SUBMISSION ON A RESOURCE CONSENT APPLICATION THAT IS SUBJECT TO LIMITED NOTIFICATION BY THE KAPITI COAST DISTRICT COUNCIL
Pursuant to section 96 of the Resource Management Act 1991

Application Number:	RM190125
Applicant:	Housing New Zealand Ltd
Proposal:	To undertake a two lot residential subdivision that does not meet the shape factor, minimum and average lot sizes, requires consent for contaminants in soil and land use consent for the construction of two dwellings prior to the certification of the subdivision that do not meet the permitted activity standards for car parking, water demand management and accessory buildings encroaching the require yard setbacks
Legal Description(s):	Lot 62 DP 23300, 35 Kaitawa Crescent, Paraparaumu

Submission by Paul Marlow of 33 Kaitawa Crescent Paraparaumu 14.4.2020

Opposition to the RM190125 35 Kaitawa Crescent Paraparaumu

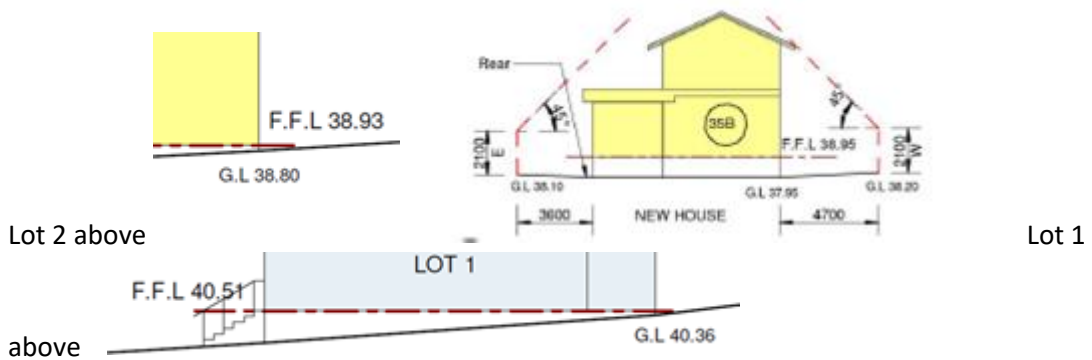
The foundation to ground clearance is wrong. The house height will need to be lifted, or the house position will need to be shifted, to comply with daylighting requirements. Please see the below copied diagrams from the RM190125 showing ground clearance for a concrete foundation, whereas the building consent plans are for a timber floor construction (shown to me on screen in council – I am still waiting on copies of the full working drawings, which I have requested from KCDC.)

- The house is close to touching the day lighting angle and the foundations are shown with base boards.

- As per the building code, the underside of the floor joist to the ground level needs to be a minimum of 450mm. (175mm minimum to the bottom of the cladding) the information provided shows ground level to the finished floor at 130mm for lot2 and lot one at 150mm both non-compliant, if site cuts are to be carried out to drop the ground level this will need to be calculated and provided as part of the resource consent, this would need to include the sloping car part areas

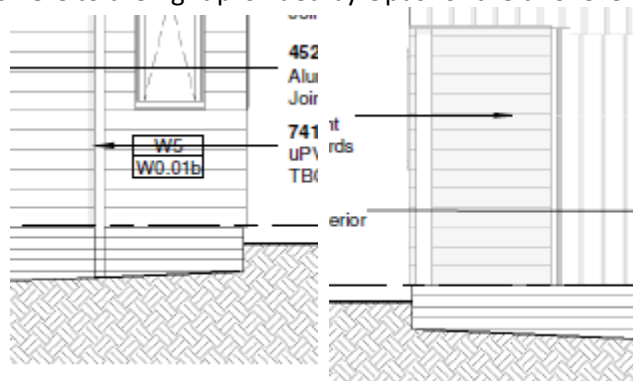
- This is a sloping site- surface water needs to be redirected away from the foundations. Where is this information please?
- The below drawn images from the RM190125 are non-compliant and don't support timber floor clearances.

- Both BC190722 & BC190676 provided by KCDC are National Multiple-use approval establishes that the plans and specifications to which it relates comply with the building code. However they are designed for a flat site and don't take into consideration the sloping site at 35 Kaitawa Crescent, which has a 3.2mtr fall from the top boundary fence to the bottom fence hence my concerns mentioned above

- The details here to the right provided by Opus for the two level home are drawn being non-

- compliant
- Im trying to save tax payers money here
